# **USNRC Region IV**

# **Regulatory Conference**

Entergy Operations Inc.
Arkansas Nuclear One

July 10, 2003

# Results (cont.) Comparison of NRC and ANO Results

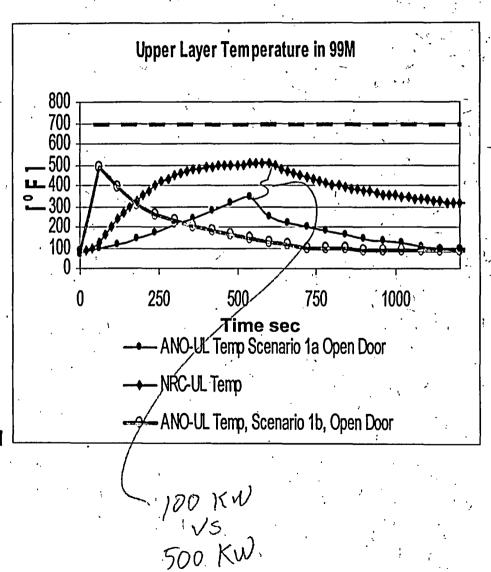
- · Damage threshold
  - NRC: 425°F
  - ANO: 700°F
- Heat release rate
  - NRC: 500KW fire peaking in 105 sec.
  - ANO: 100KW peaking in 12 min (Scenario 1a) + cable fires and high energy fault in A4 switchgear and cable fires (Scenario 1b)
- High energy arcing fault in the 4KV switchgear
  - NRC: Not analyzed
  - ANO: Limiting scenario in terms of its consequence, i.e., affected circuits and timing
- Meither analysis reaches 700°F
